LF1000 NEW TYPE SWITCH FITTED AFTER MARCH 2009

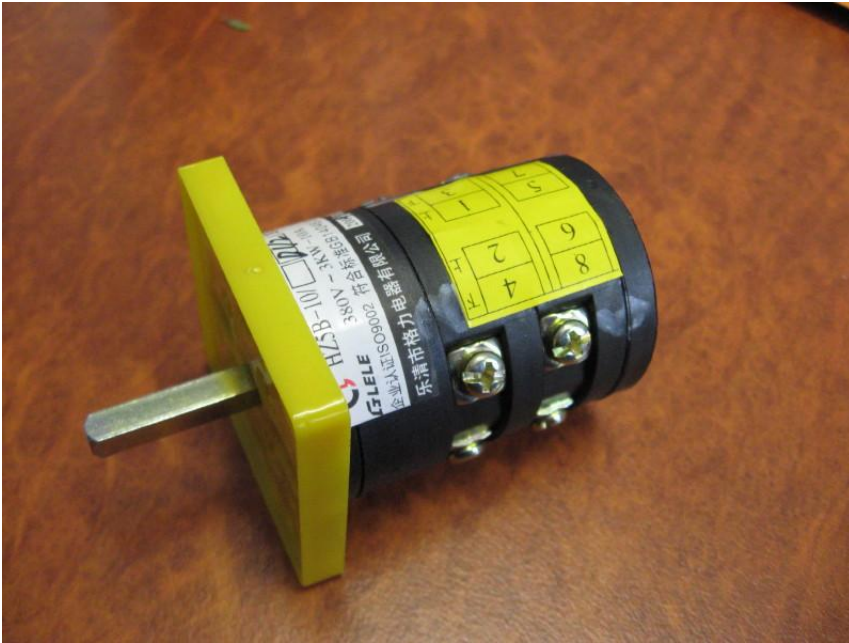
PREVIOUS OLD SWITCH LATHE WIRES		NEW SWITCH
RED 5	TO	TERMINAL 6-2-8 (ARE BRIDGED)
BLACK 13	TO	TERMINAL 5
YELLOW 7	TO	TERMINAL 1
BLUE 4	TO	TERMINAL 7
